Mr. Frank Clinton,  
Programme Manager,  
Office of Climate, Licensing and Resource Use,  
Environmental Protection Agency,  
P.O. Box 3000,  
Johnstown Castle Estate,  
Co. Wexford

6<sup>th</sup> March 2009

RE: Request for Technical Amendment to Conditions 5.4, 5.5, 5.8 and 5.10–  
Greenstar Tallaght Depot W0079-01

**Proposed Surface Water Drainage Upgrading Works**

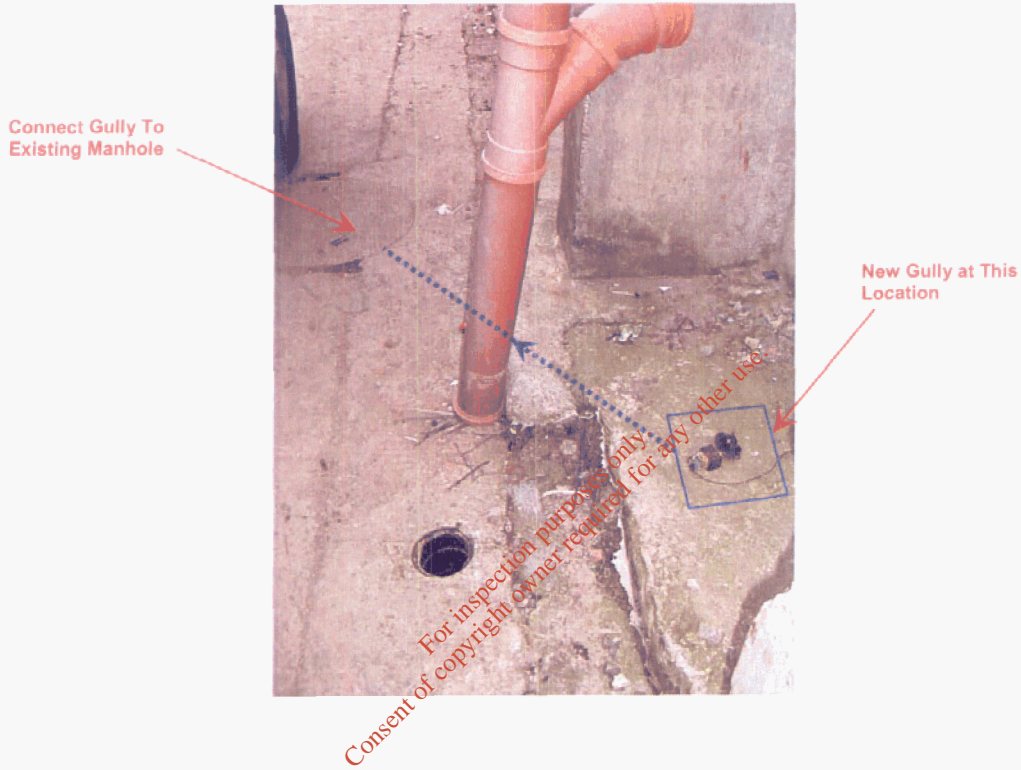
- 1.0 As the existing ground is a reinforced concrete yard area all the proposed works will require saw cutting and excavation of concrete slab.
- 2.0 Construct new 225mm diameter uPVC storm drain between new manhole 'G' and new manhole 'F' – approximate length 25m. Manhole 'G' 900mm diameter – Manhole 'F' 1050mm.
- 3.0 Manhole 'F' to be constructed as a catch-pit manhole to enable capture and settlement of solids by providing for a 1.0m deep sump area within the manhole.

- 4.0 3 No. gullies to be constructed at the locations shown with connection to the 225mm diameter pipe between new manholes 'G' and 'F'.
- 5.0 Construct new 225mm diameter uPVC storm drain between manhole 'F' and new manhole 'D' – approximate length 4.0m. New manhole 'D' to be constructed as a 2100mm diameter catch-pit manhole to enable capture and settlement of solids by providing for a 1.5m deep sump area within the manhole.

- 6.0 Construct new 225mm diameter uPVC storm drain between existing manhole 'C' and new manhole 'D' – approximate length 4.3m.
- 7.0 Existing storm drain between manhole 'C' and existing manhole 'B' to be abandoned by plugging and/or grouting or concreting the upstream and downstream end for a minimum distance of 500mm. Manhole cover and frame at 'C' to be replaced.

- 8.0 New Class 1 Bypass Interceptor, Type CP8BP by Carlow Precast Tanks Ltd, to be constructed at the location shown (*Spec. sheet from Carlow Precast attached*). A 225mm diameter uPVC drain to be constructed between manhole 'D' and the inlet to the interceptor (approximate length 1.2m). A 225mm diameter uPVC drain to be constructed between the outlet from the interceptor to manhole E (approximate length 1.2m).

- 9.0 Following placing of the bypass interceptor cover slab as supplied, built-up to 200mm below existing ground level with well compacted C1804 material. Interceptor openings and access points to be built-up with brickwork or blockwork. Finished with 200mm thick reinforced concrete slab (approx. 3.2m x 1.9m), A393 mesh top and bottom, profile and tie into existing ground levels.

- 10.0 Construct new 900mm diameter manhole at 'E'.
- 11.0 Construct new 225mm diameter uPVC storm drain between manhole 'E' and existing manhole 'A' - approximate length 4.3m.

- 12.0 Break into manhole 'A' as make good as required.
- 13.0 Existing manholes covers and frames at 'A' and 'B' to be removed and replaced with 2.0m x 2.0m x 0.25m thick reinforced concrete cover slabs. Suitable lifting eyes are to be cast into each of these covers. The covers are placed flush, level and tie into existing ground levels.

- 14.0 Manhole covers C, D, F, G and covers to the bypass separator to be Group 5 Class E600 in accordance with EN124. Manhole cover E to be a double sealed cover and Group 5 Class E600 in accordance with EN124. Proposed gully covers to be Group 5 Class E600 in accordance with EN124.

- 15.0 Existing manholes 1, 2, 3, 4, and 5 to be abandoned by removing manhole cover and frame, plugging inlet and outlet pipes at each manhole and backfilling each manhole with concrete and finished flush with existing ground level – approximate volume of concrete required for each manhole is 0.5m<sup>3</sup>. 1 layer of A393 mesh to be placed 40mm below ground at each of these backfilled locations.

16.0 Existing roof water downpipe to the north west corner of the waste transfer shed to be repaired and fixed in place. In order to prevent any surface water run-off from the yard area entering the roof water drainage system a new gully to accommodate this down pipe is to be constructed within the raised area as shown in the photo below, with connection to the existing adjacent manhole. The cover of this manhole to be replaced with a Group 5 Class E600 double seal cover in accordance with EN124.
